RE: Request for Approval of the Clews Subdivision located at 799 South Street, Tax Map 132 / Lot 24

On behalf of the Noele M. Clews Revocable Trust we hereby submit a request for Subdivision Approval at 799 South Street. The project team met with the Technical Advisory Committee on July 2, 2019 to review the proposal. The Technical Advisory Committee voted to recommend Preliminary and Final Subdivision Approval with the stipulations listed herein. Responses to the stipulations are highlighted in **Bold Text**:

CLEWS SUBDIVISION
799 SOUTH STREET
PORTSMOUTH, N.H.

SUBDIVISION PLAN
TAX MAP 132 - LOT 24
OWNER:
NOELE M. CLEWS
REVOCABLE TRUST
CHRISTOPHER CLEWS, TRUSTEE
PROPERTY LOCATED AT:
799 SOUTH STREET
CITY OF PORTSMOUTH
COUNTY OF ROCKINGHAM
STATE OF NEW HAMPSHIRE

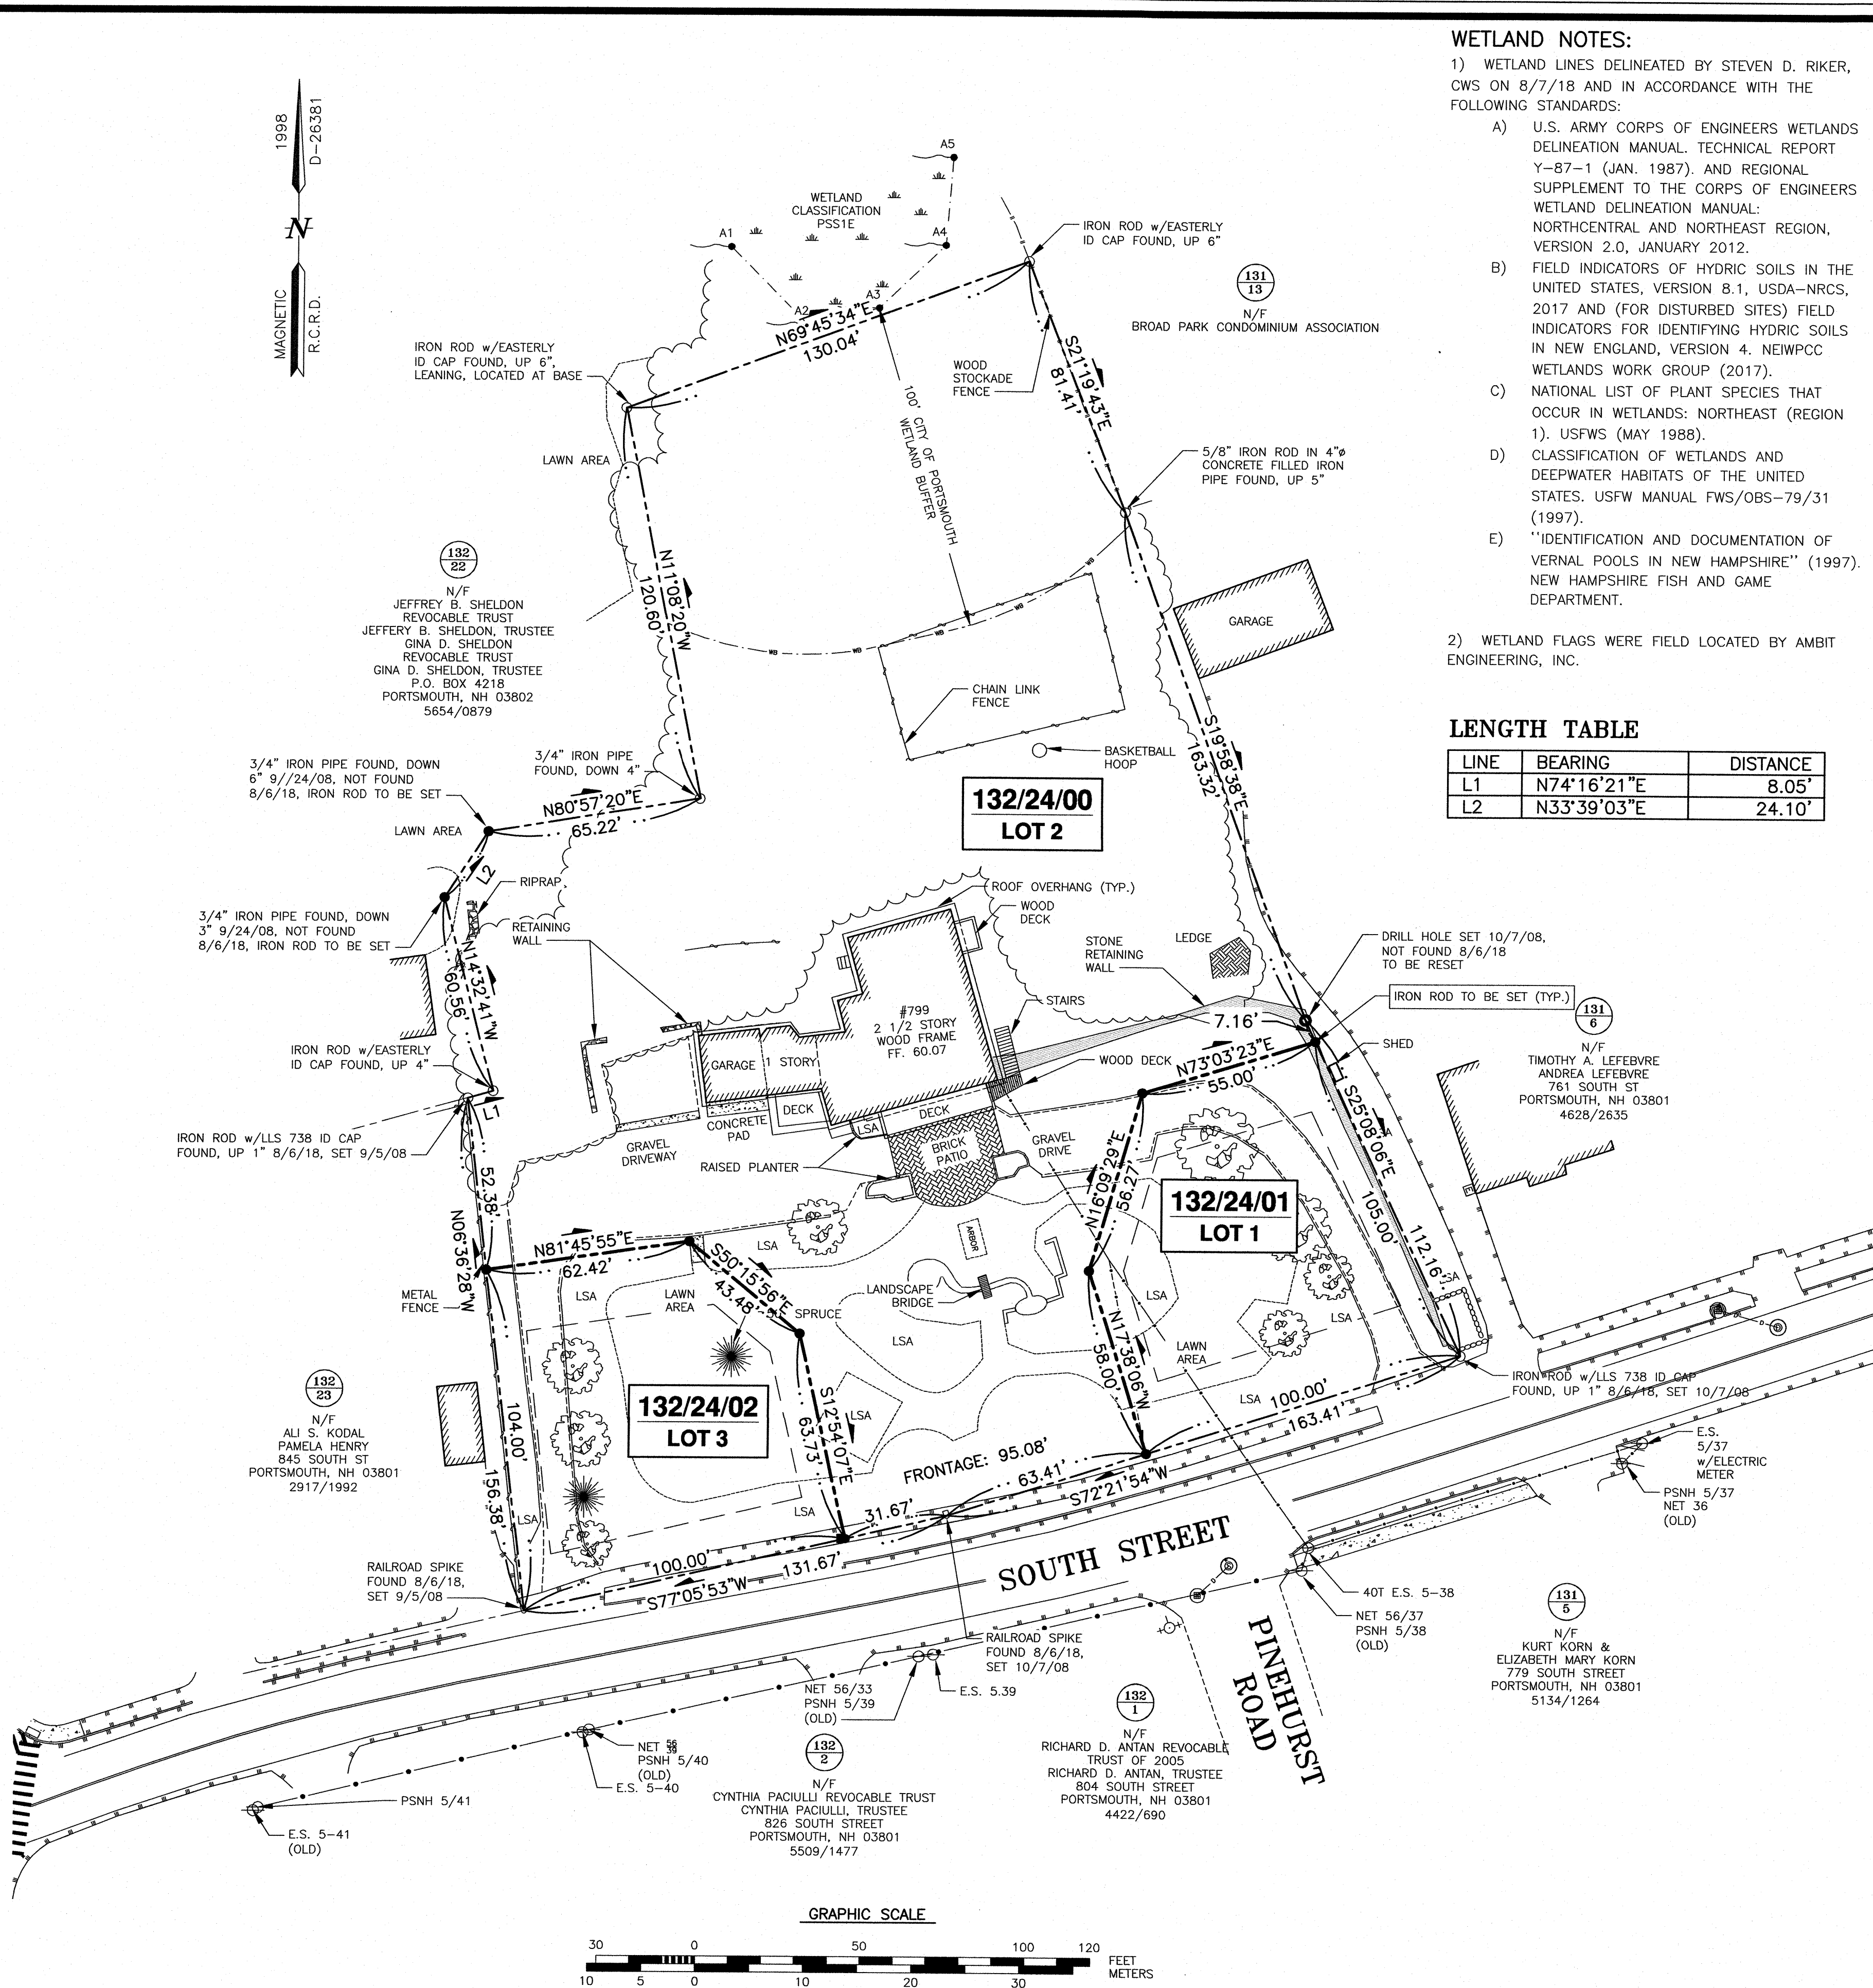
1. Change the grass paver to use a surface that is readily apparent as a drivable surface for the Fire Truck access. Add note to plans that this area will be maintained year round to allow fire truck access as necessary. **The drivable area for fire truck turn-in has been revised to granite pavers from grass pavers, with an option to provide asphalt paving. Also see Note 8 on the Subdivision Plan.**

8. The plans shall note that the removal of the existing and construction of the proposed driveways shall be done in a sequence that will maintain driveway access to existing residences at all times. **Note #8 of the Subdivision Plan states, "Prior to discontinuance of the driveway access to Lot 2, the new Lot 2 / 3 Driveway shall be installed and maintained for the occupants."**

1. An easement shall be provided to benefit the City wherever the sidewalk crosses private property including a 2' paralleling the sidewalk to allow for snow storage. **Note #9 on the Subdivision Plan states that an easement shall be provided.**

- THE PURPOSE OF THIS PLAN IS TO SHOW THE SUBDIVISION OF TAX MAP 132 LOT 24 IN THE CITY OF PORTSMOUTH INTO 3 LOTS.
- PRIOR TO DISCONTINUANCE OF THE DRIVEWAY ACCESS TO LOT 2 THE NEW LOTS 2 & 3 DRIVEWAY SHALL BE INSTALLED AND MAINTAINED FOR THE OCCUPANTS. ALSO THE DRIVEWAY SHALL BE MAINTAINED TO ITS FULL WIDTH TO ALLOW FIRE TRUCK ACCESS TO 779 SOUTH STREET.

UTILITY SITE PLAN

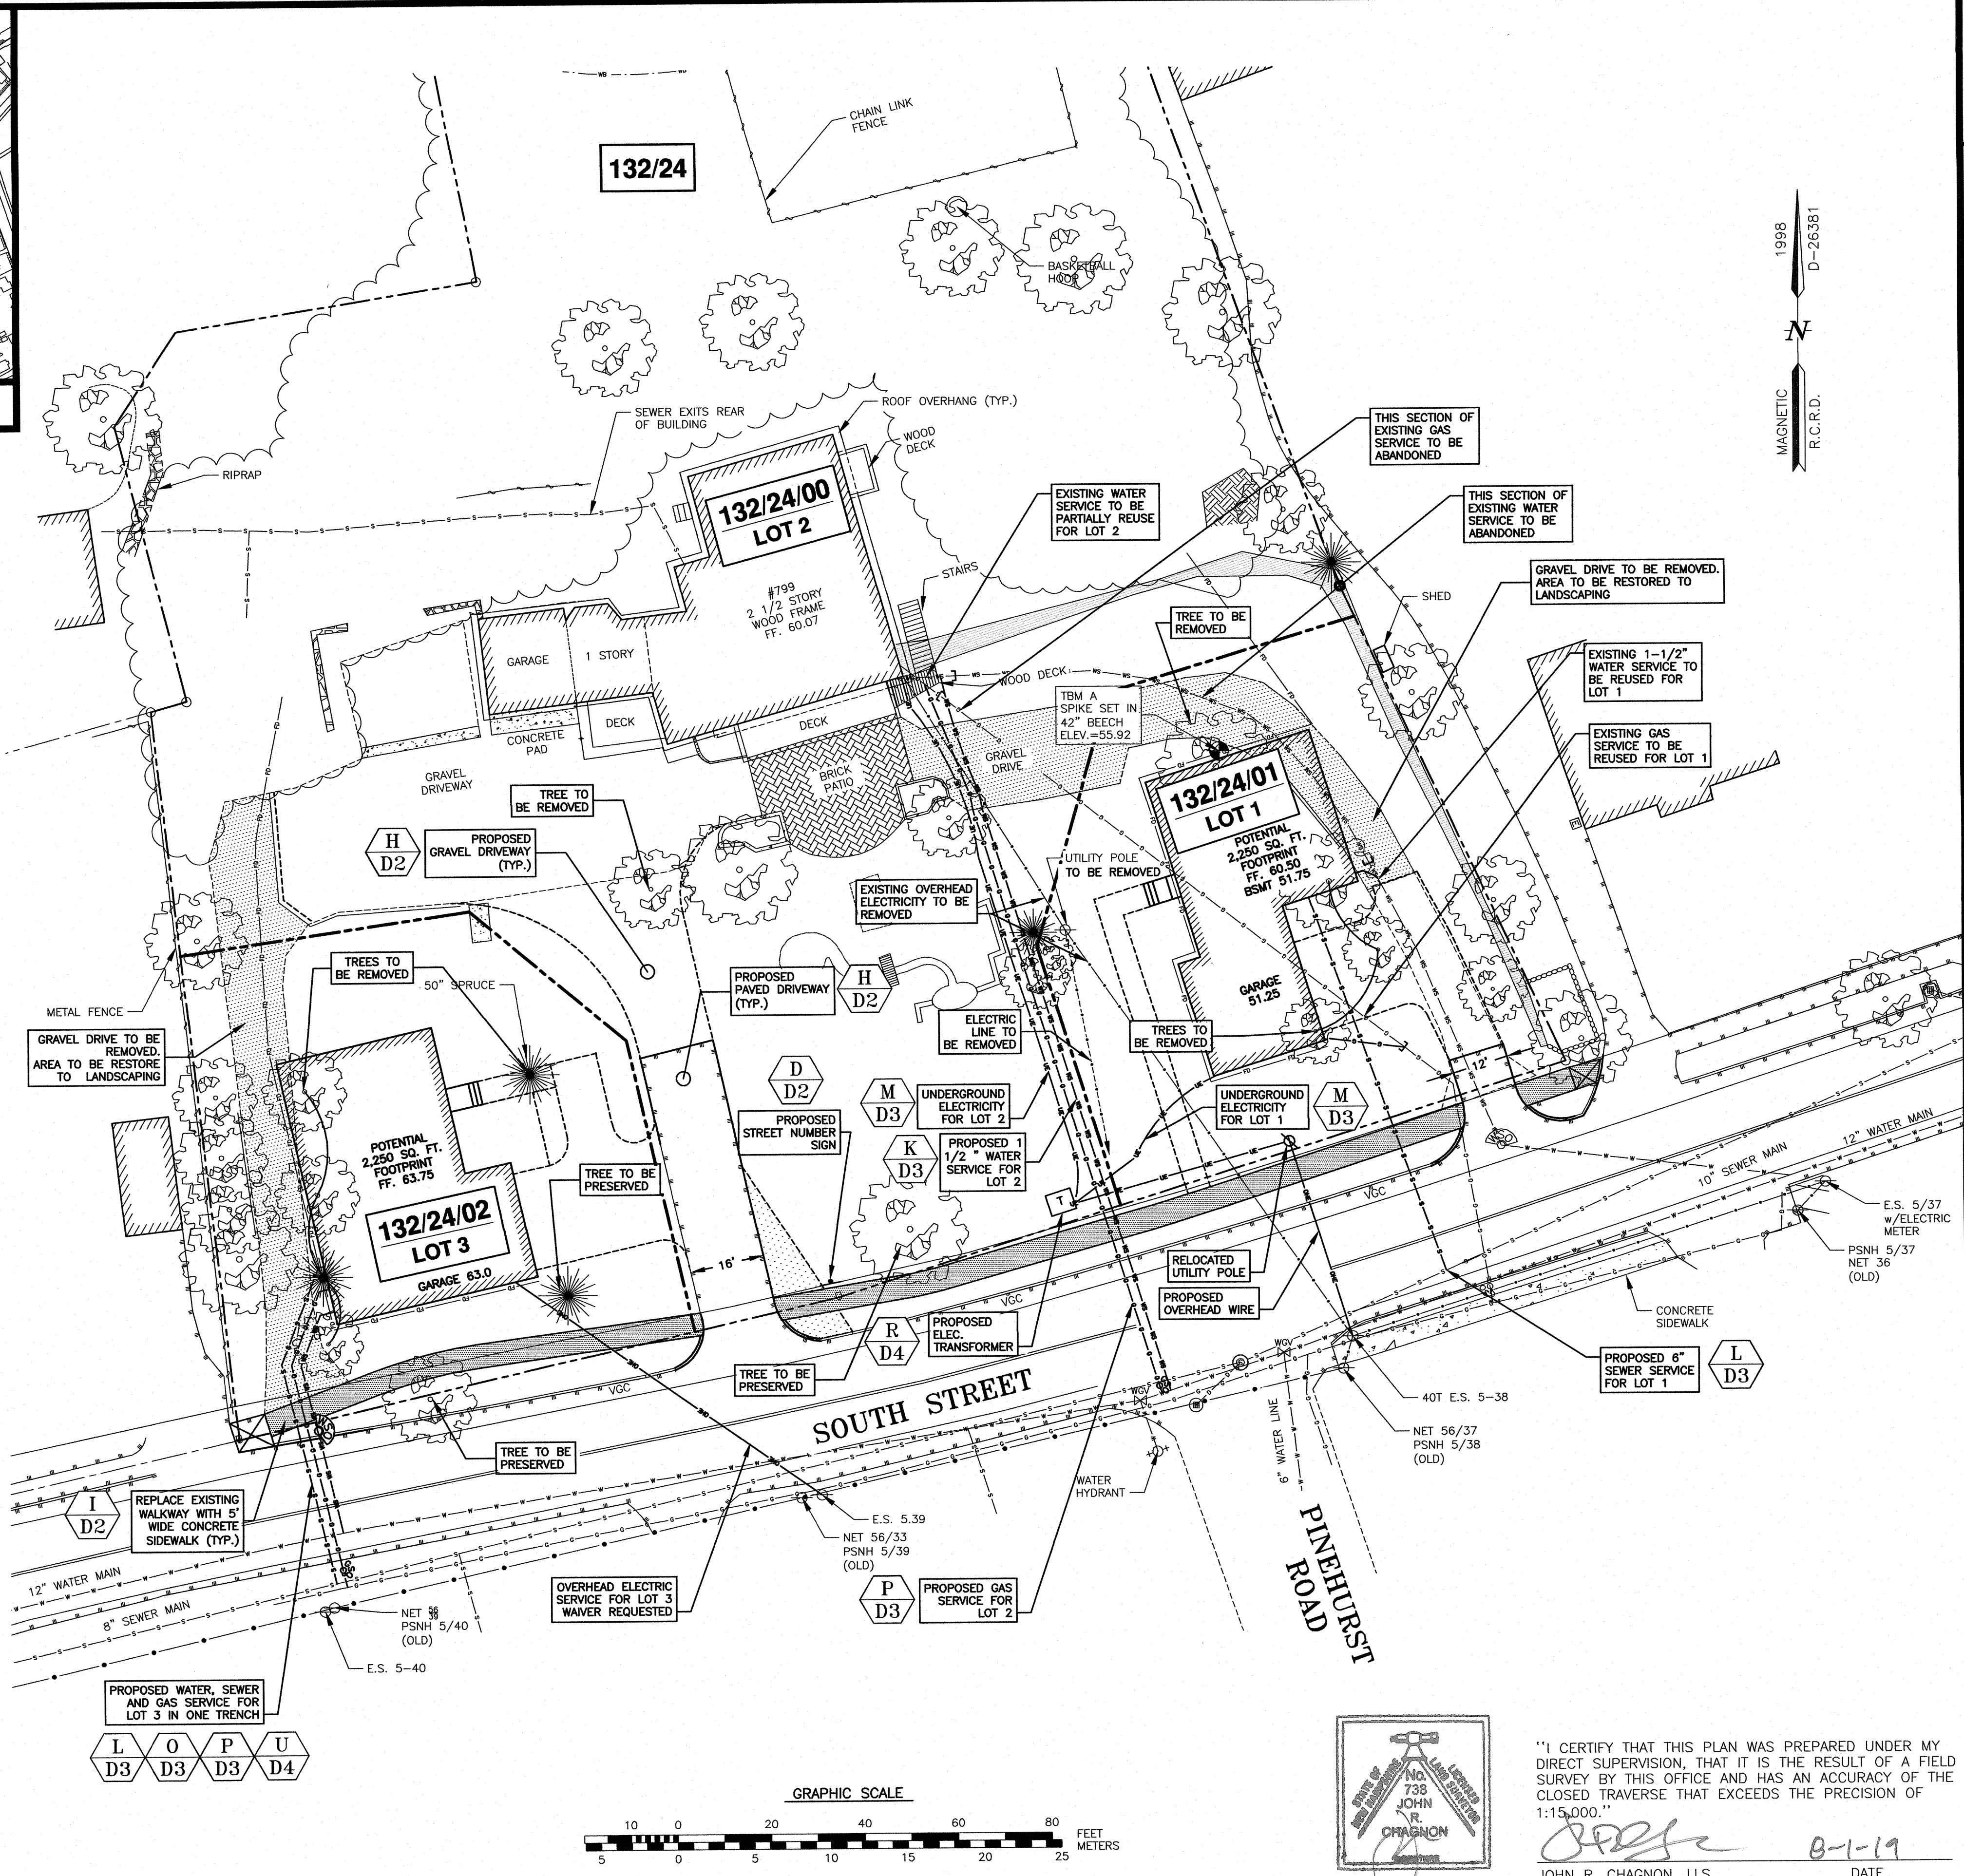
4. Relocate the utility pole on the plan to the spot approved by the City. **The utility pole has been relocated to reflect the spot approved by the city, see the Utility Plan Sheet C2.**

5. Add note to plans that construction of utilities and driveways shall impact the sidewalk for no more than 1 week. Safe access shall be restored each night. **Note #8 has been added to Sheet C2.**

6. The sidewalk in front of the property up to the nearest adjacent driveways shall be replaced with concrete meeting the City's specifications. This work shall take no more than 1 week to full restoration. All sidewalk construction shall meet ADA standards. **Note #9 has been added to Sheet C2.**

- 7) BUILDING LOCATIONS ON LOTS 1 & 3 ARE PRELIMINARY AND SUBJECT TO CHANGE.
- 8) CONSTRUCTION OF UTILITIES AND DRIVEWAYS SHALL IMPACT THE SIDEWALK FOR NO MORE THAN 1 WEEK. SAFE ACCESS SHALL BE RESTORED EACH NIGHT.
